Subject: Preventive measure against aileron flutter.

Serial number applicability: All ASW 20 variants and serial nos.
20001 thru 20860; 20950 and 20951.

Compliance: Immediately, prior to the next take-off.

FIG.1

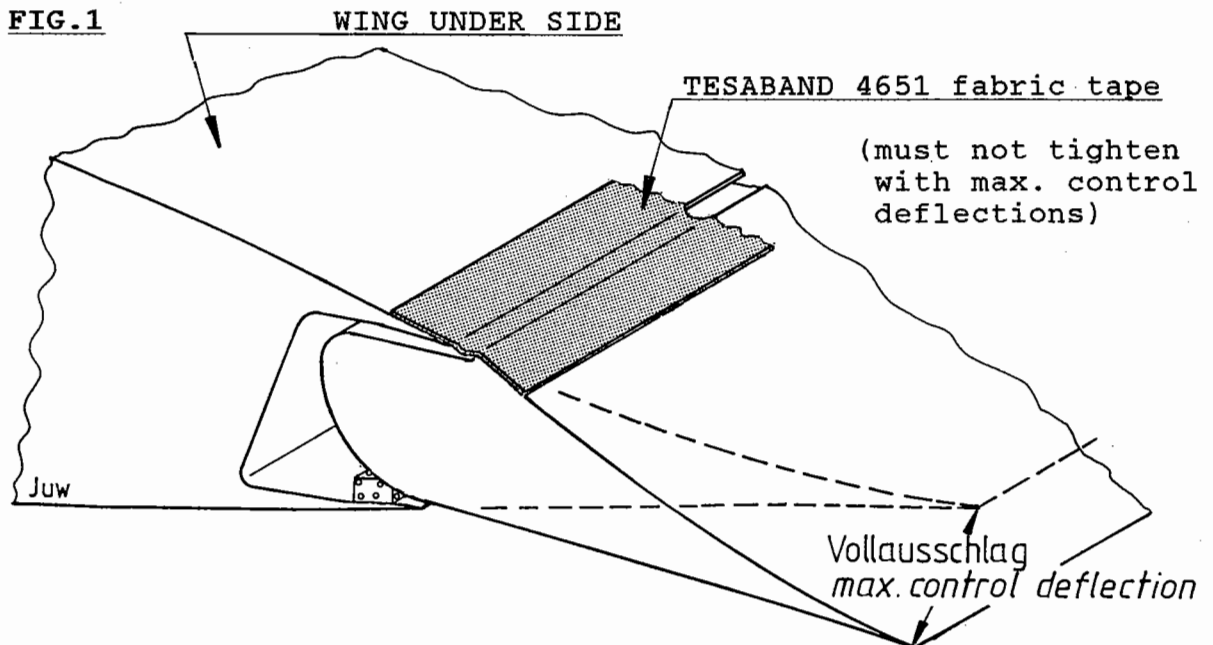
1. Prior to the next take-off it must be checked whether the control surface gap on the wing under side is equipped with a sealing, i.e. either
 - 1.1 with the factory-standard, plastic-treated fabric-tape TESABAND 4651, white, 38 mm wide (see Fig.1); in that case the plastic coat on the fabric must not be damaged, discolored or even weather-worn; the tape must not tighten with full control surfaces deflections.
or

Fig. 2

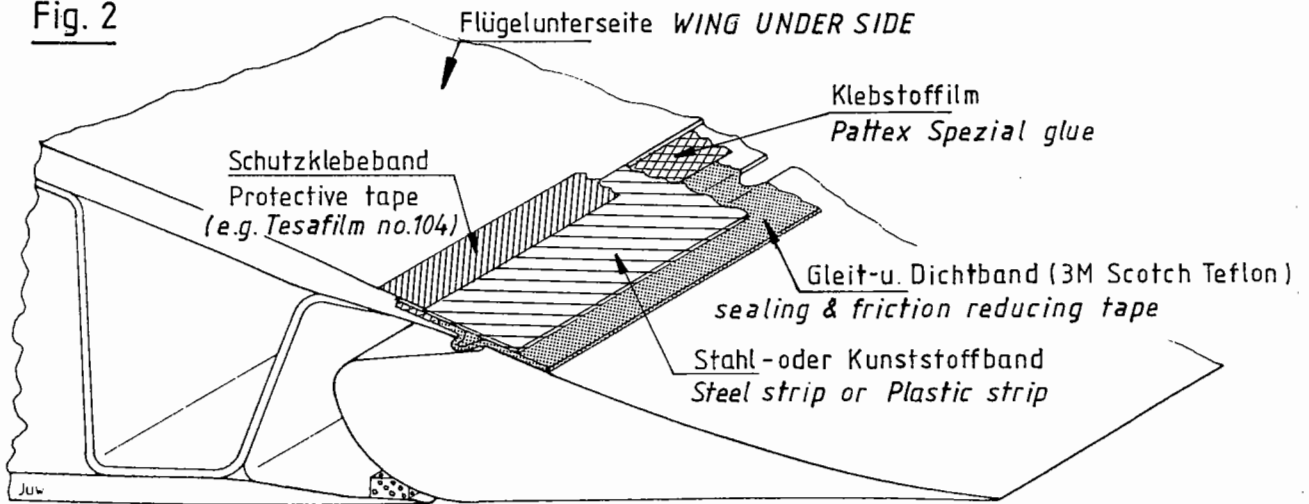
- 1.2 with the pre-curved steel strip (0,07 mm thick) or the pre-curved plastic tape (MYLAR 0,25 mm thick) respectively; in that case check that both require absolutely a Teflon sealing tape underneath for the purpose of sealing the gap and reducing the friction (see Fig. 2).If 1.1 or 1.2 are positive, the ASW 20 can be continued in operation without any restrictions.

2.2 In case of the elastic lip sealing: this has to be renewed as shown in Fig.2, following the Maintenance Instruction J, Issue III; alternatively, the elastic lip sealing can be new applied instead of the above TESA tape sealing.
